Subject: **COLUMBIA GENERATING STATION, DOCKET NO. 50-397
RESPONSE TO REQUEST FOR ADDITIONAL INFORMATION
REGARDING LICENSE AMENDMENT REQUEST TO REVISE
COLUMBIA EMERGENCY PLAN**

Response to Request for Additional Information Regarding License Amendment Request to Revise Columbia Emergency Plan

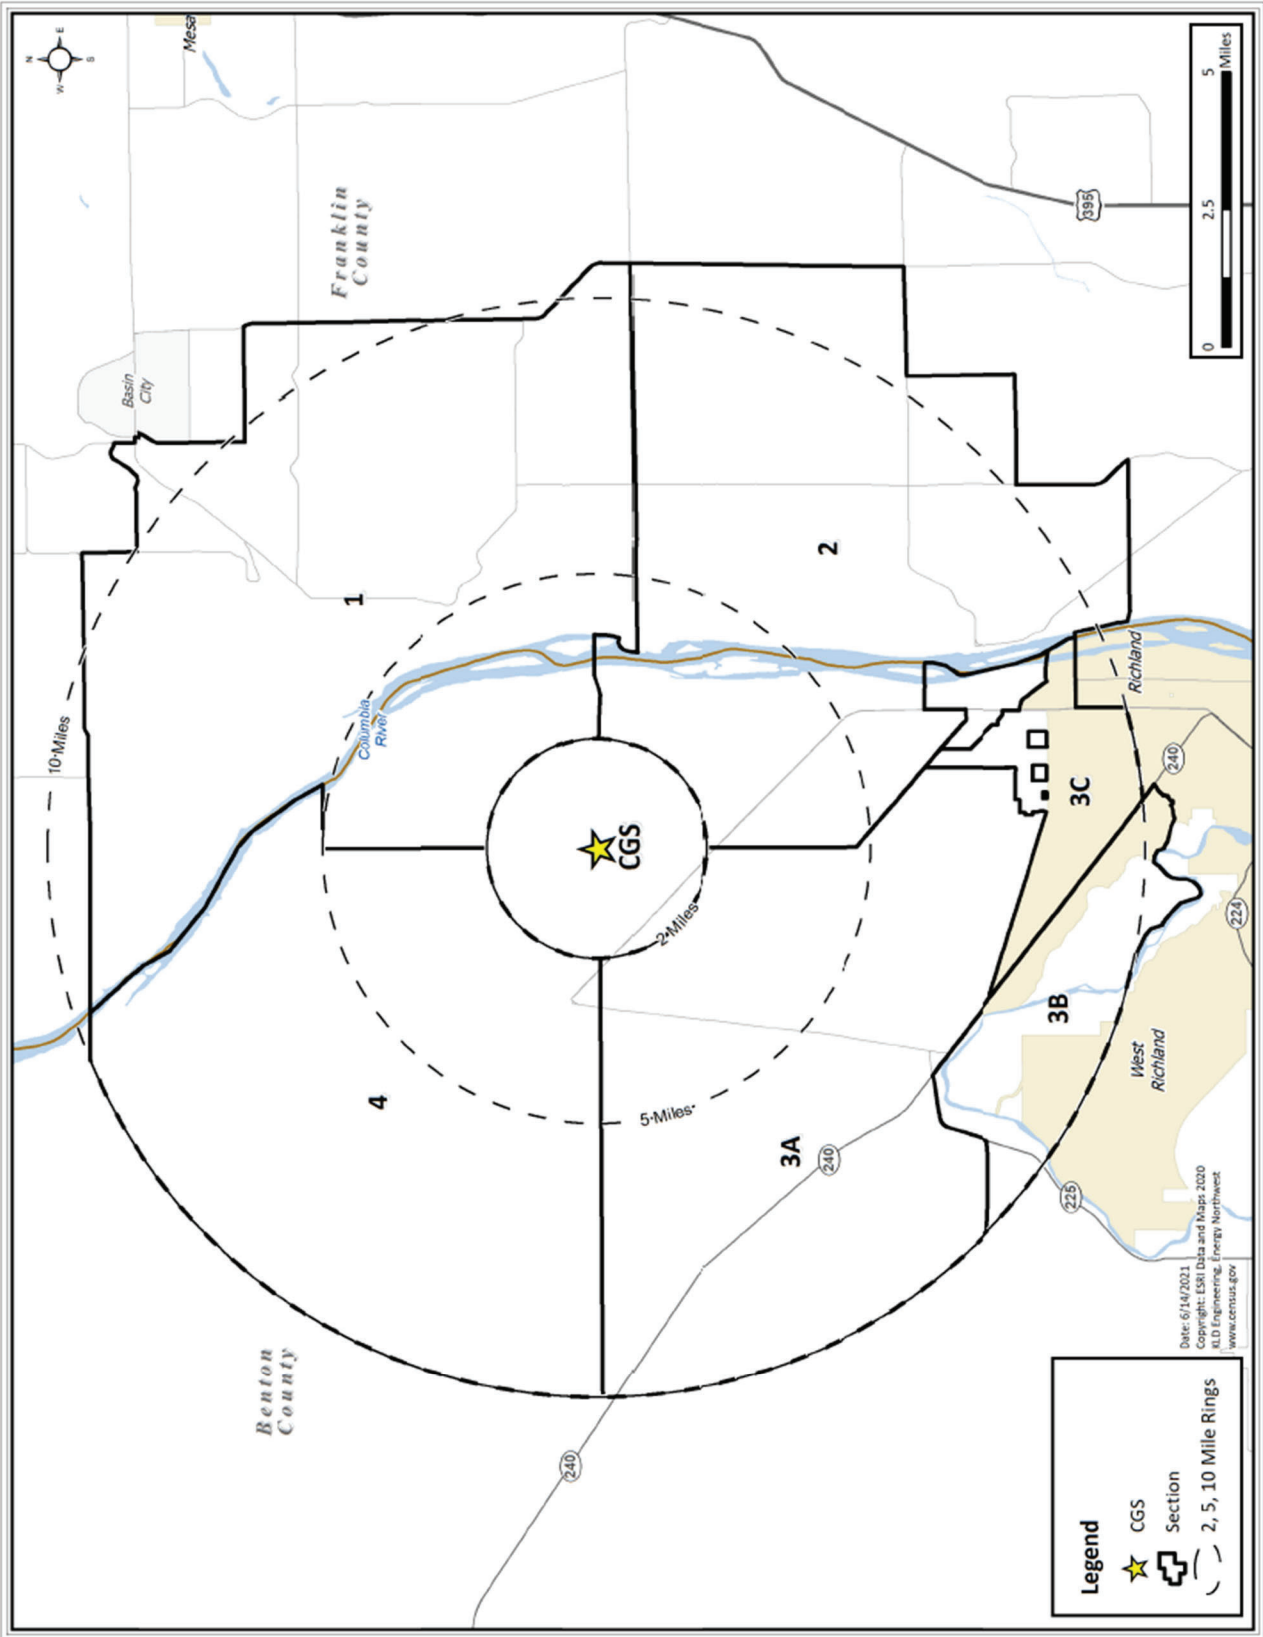
In the original submittal, dated January 30, 2024, (pages 56 & 57 of 98) Section J.8.a of Enclosure 2 states in part,

However, Section M.3, "*Effect of Changes in Permanent Resident Population*," of the "*Columbia Generating Station Development of Evacuation Time Estimates*," dated July 27, 2022 (ML22242A210), states,

Section IV of Appendix E to 10 CFR Part 50, and NUREG/CR-7002, Rev. 1, Section 5.4, require licensees to provide an updated ETE analysis to the NRC when a population increase within the EPZ causes the longest 90th percentile ETE

values (for the 2-Mile Region, 5-Mile Region or entire EPZ) to increase by 25% or 30 minutes, whichever is less.

Provide technical justification for why Energy Northwest did not include the 5-Mile Region as a criteria to update the ETE report.

Columbia is located on the Department of Energy (DOE) site in Richland, WA, and has an extremely low resident population throughout the Emergency Planning Zone (EPZ). There are no permanent residents in the 0 to 4 mile ring. The 2024 Population Update Analysis identified 85 permanent residents in the 4 to 5 mile ring east of the site in Sections 1 and 2. In 1983 when the NRC approved the initial Emergency Plan for Columbia, the resident population in the 4 to 5 mile ring was 80 persons, which represents a change of approximately 6% of total resident population in those two sections over the past four decades.

Due to the low population and geographical area surrounding Columbia, the Protective Action Recommendation (PAR) scheme does not include actions for a 5-mile distance. The following figure shows Sections 1 through 4, which cover the full area between 2 to 10 miles. The bases provide for an initial PAR of 2-mile radius and 10 miles downwind upon entry into a General Emergency classification. The offsite PARs, dated July 17, 2014, were developed in conjunction with, and approved by, representatives from utility, state, county, the DOE, and the Federal Emergency Management Agency.
